**3.1. NRSP PARCEL WW-71, PLAY CARE LEARNING CENTER - 4050
BASELINE ROAD - FILE #PL16-0229**

ITEM III-A: DESIGN REVIEW PERMIT – PLAY CARE LEARNING CENTER – 4050 BASELINE ROAD – FILE # PL16-0229

The applicant requests approval of a Design Review Permit to construct a 12,145 square foot daycare center with associated site improvements.

Figure 2: Site Plan

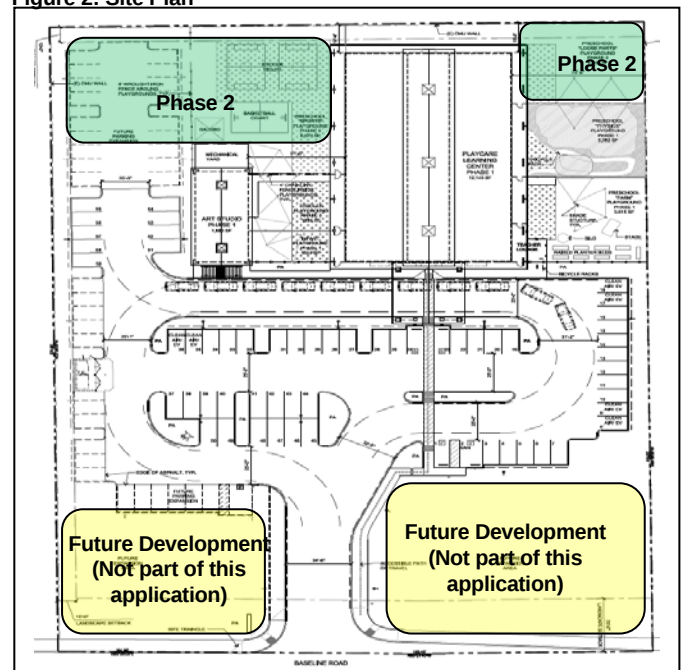
3. A minimum of one (1) bicycle locker shall be provided onsite for employees. The quantity and type of the locker shall be indicated on the site plan. (Planning)

4. A six foot landscape finger shall be constructed along the south perimeter of the trash enclosure and planted with a tree and shrubs. All landscaping located around the trash enclosure shall be installed with Phase 1 of the project. (Planning)

5. Additional evergreen and deciduous trees shall be planted at 35' on center along the northern and western property lines to help screen views of the Play Care Learning Center from adjacent residents, to the satisfaction of the Planning Division. (Planning)

- ii) Accessible Parking spaces and crosswalks shall be signed, marked and maintained as required by Chapter 11B of the CBC.
 - iii) Accessible parking and exterior route of travel shall comply with CBC, Chapter 11B. As such, please consider relocating accessible parking spaces 1 & 2. (Building)

Figure 5: Landscape Plan

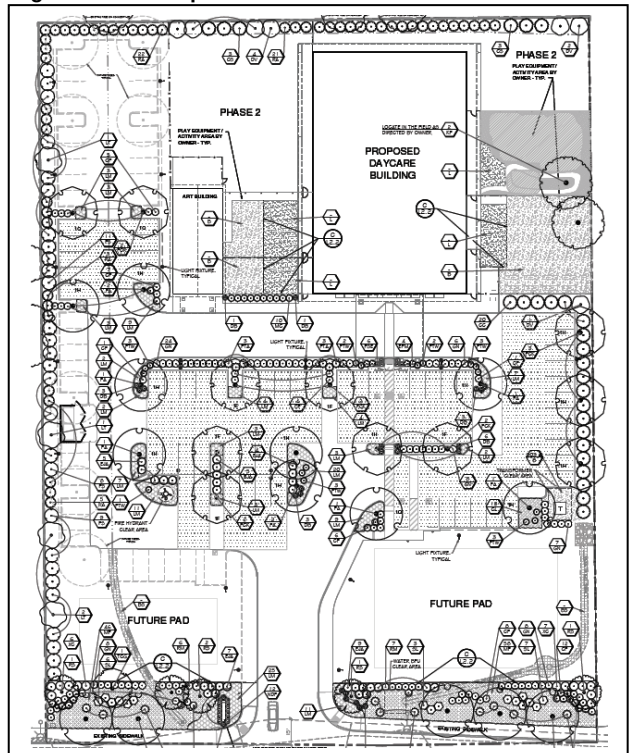
Landscaping: Consistent with the NRSP, the project will provide a 35-foot wide landscape setback along Baseline Road that will be planted with five London Plane Trees, five African Sumac Trees, one Greenspire Littleleaf Linden Tree, a variety of shrubs and groundcover. Landscaping internal to the site will include a ten-foot wide planter located around the north, west, and a portion of the east property boundary and will consist of Cape Myrtles Trees and tall growing bushes, shrubs and groundcover. The landscape plan includes similar plantings that are used on the adjacent parcels and will provide an appropriate transition between the residential properties. However, staff has included Condition #4 requiring that a landscape finger be added to the south of the proposed trash enclosure (consistent with the CDGs), and that all landscaping around the trash enclosure be installed with Phase 1. Additionally, based on feedback received at the neighborhood meeting and to help further screen views of the building from the adjacent neighbors, staff has included Condition #5 requiring additional evergreen trees be planted along the western and northern property lines at a minimum of 35' on center. These trees shall not produce fruit that drops and shall provide a medium to large canopy. Finally, per the Community Design Guidelines, landscape lighting shall be pedestrian scale and measure approximately 10' in height. Accordingly, the three light poles located along the western property line shall be reduced in height to a maximum of 10' (see Condition #6).

6. The three light poles located in the eastern landscape planter shall be reduced in height to a maximum of 10 feet. (Planning)
7. The undeveloped pads located adjacent to Baseline Road shall be stabilized and hydro-seeded to ensure the vacant pads are appropriately maintained. (Planning)
